SECTION 00 91 13 – ADDENDA (ADDENDUM #2 – ISSUED 08/24/23)

- A. Project Name: RVCC Lab Renovations
- B. Owner: Community College System of New Hampshire
- C. Architect: Warrenstreet Architects, Inc.
- D. Architect Project Number: 3773
- E. Date of Addendum: **August 24, 2023.**

## CURB CAP DETAIL

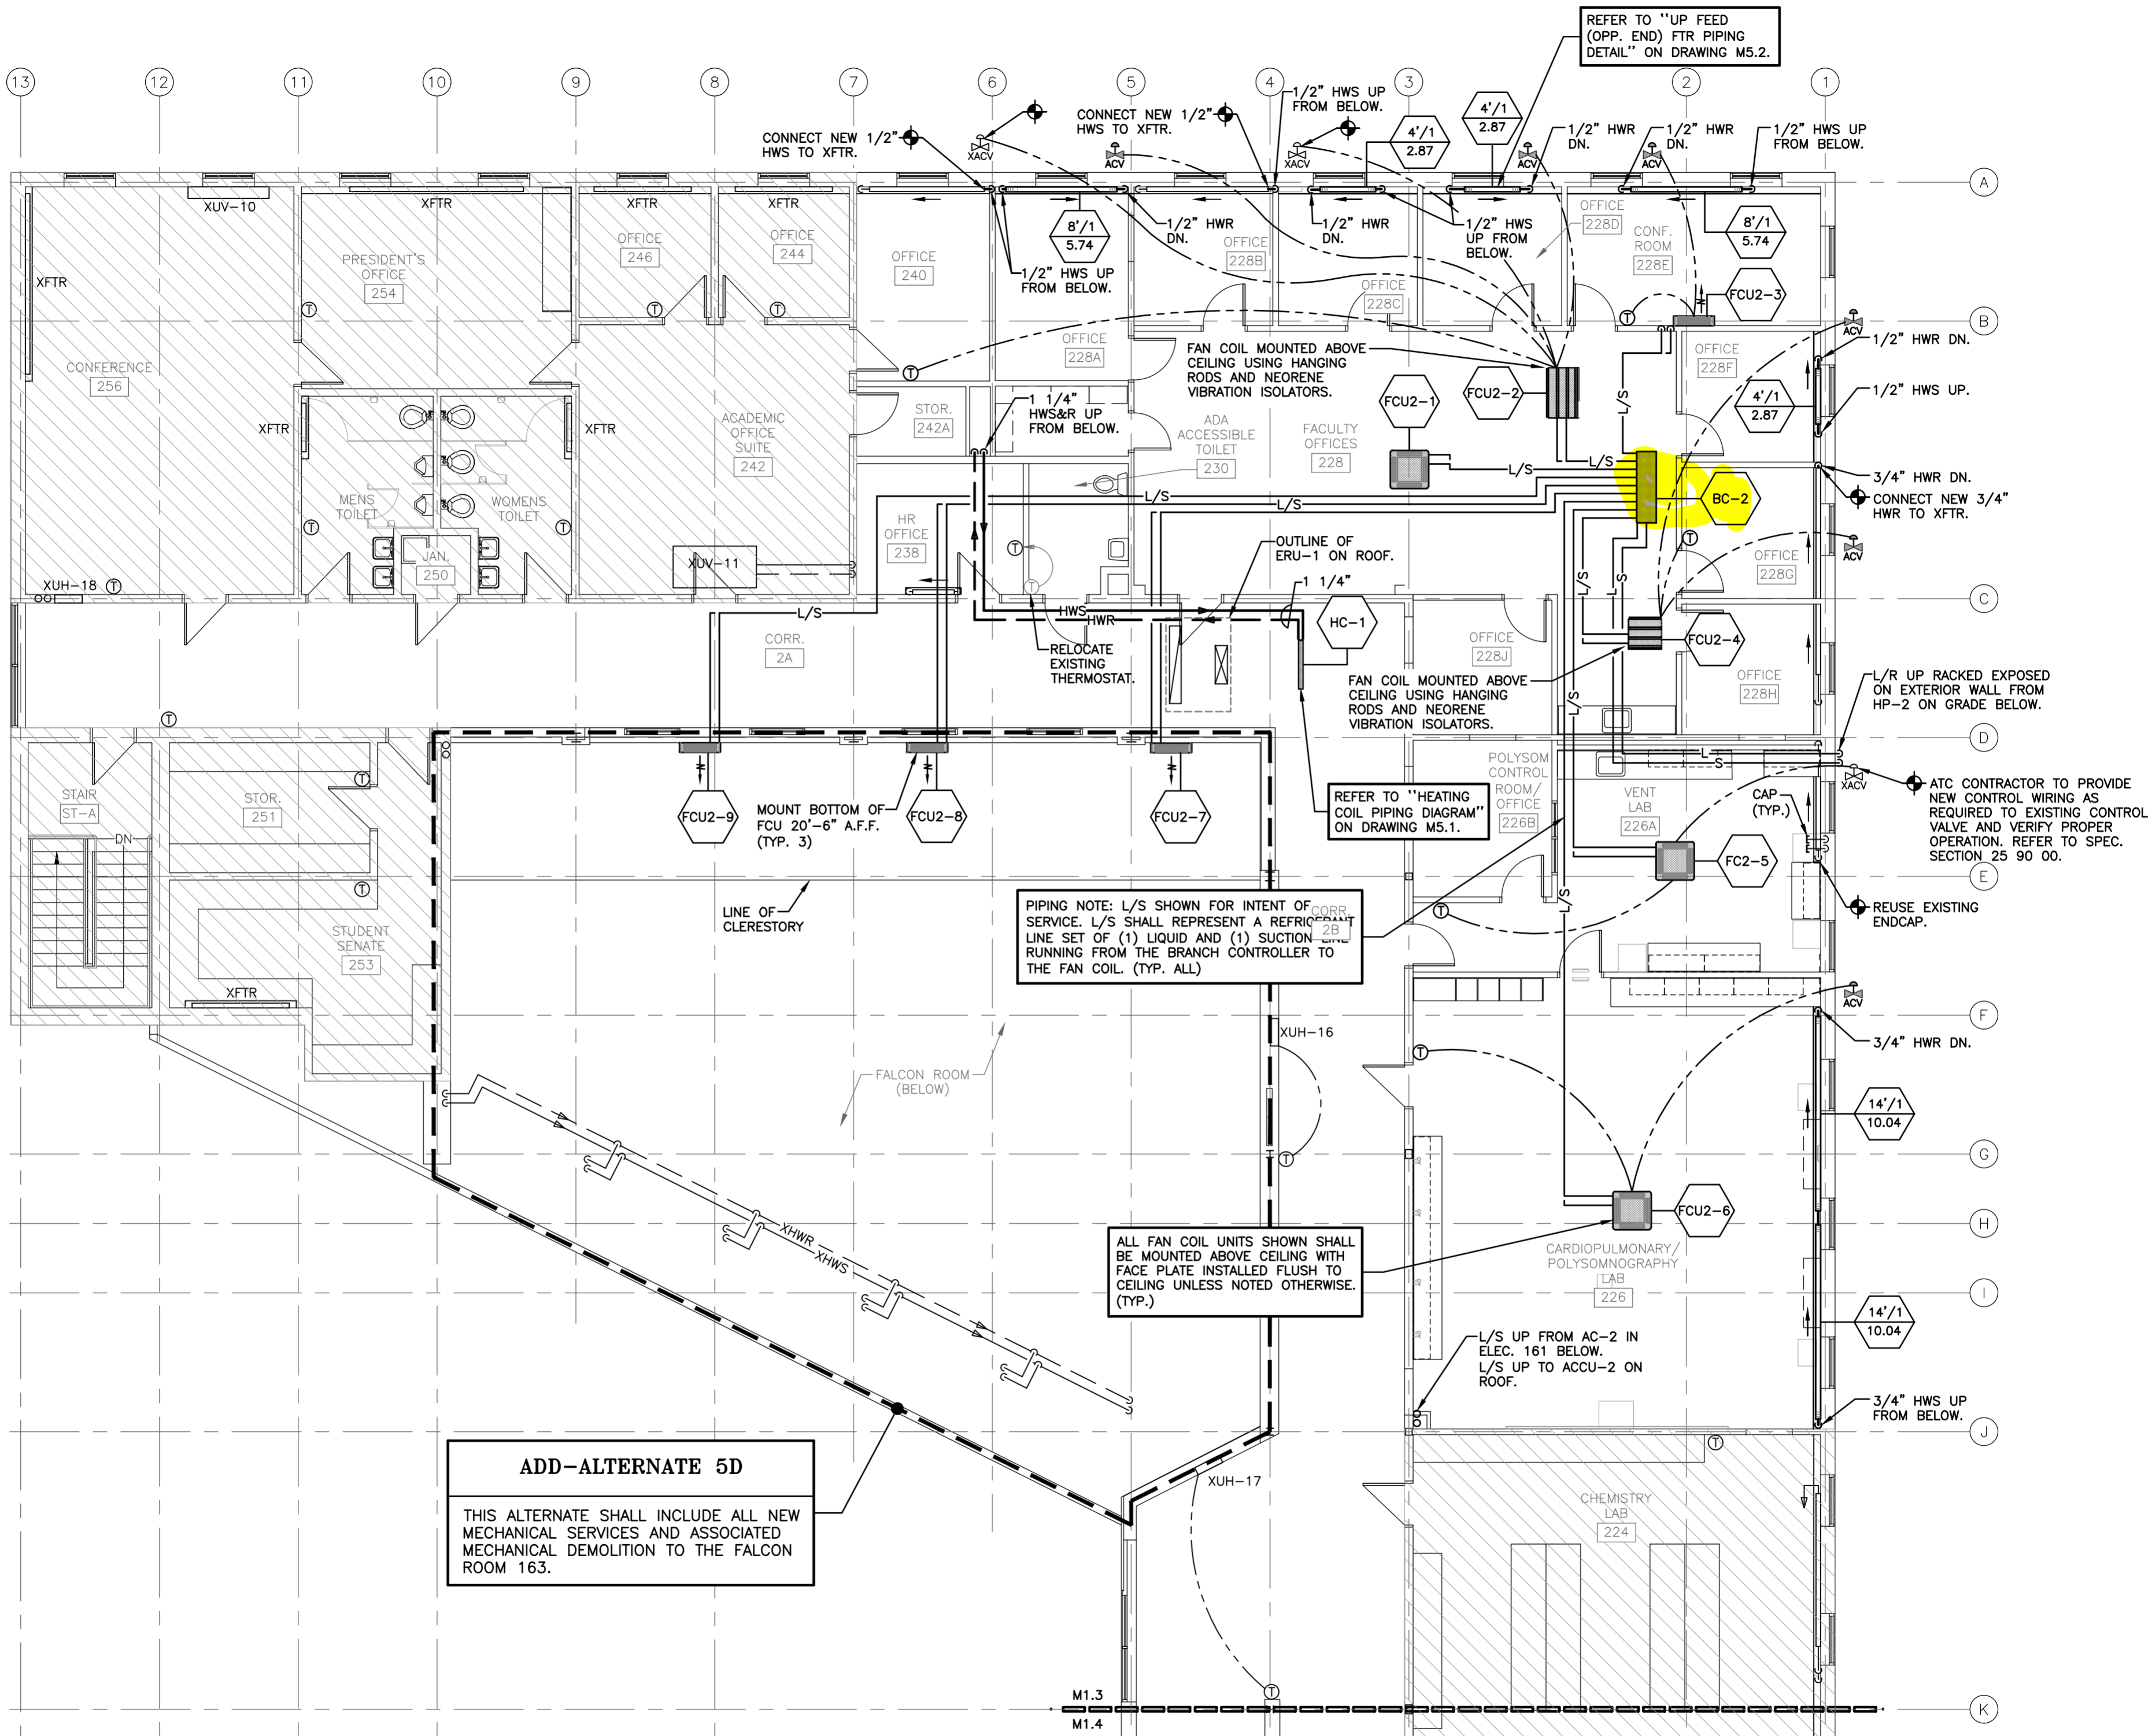
1. RESPONSE: Panels are to be 8' in length.
- D. QUESTION: Demo Note # 4 on M1.2 says to insulate, cap and make watertight the roof curbs for the exhaust hoods. Please provide a detail for this work.

1. RESPONSE: See attached detail.
- E. QUESTION: Note 5 on M1.2 says to connect new liquid & suction piping from Fc-1 to XBC-2. How far away is XBC-2?
1. RESPONSE: See attached for anticipated location. Approximate distance is 100', final length may vary with run of piping.

WATERTIGHT, COUNTER  
FLASHED SHEET METAL CAP.  
FIELD VERIFY EXACT SIZE.

CAP SIDES TO EXTEND  
MIN. 4" DOWN EXISTING  
CURB. PROVIDE 1/4"  
HEMMED OUT DRIP EDGE.
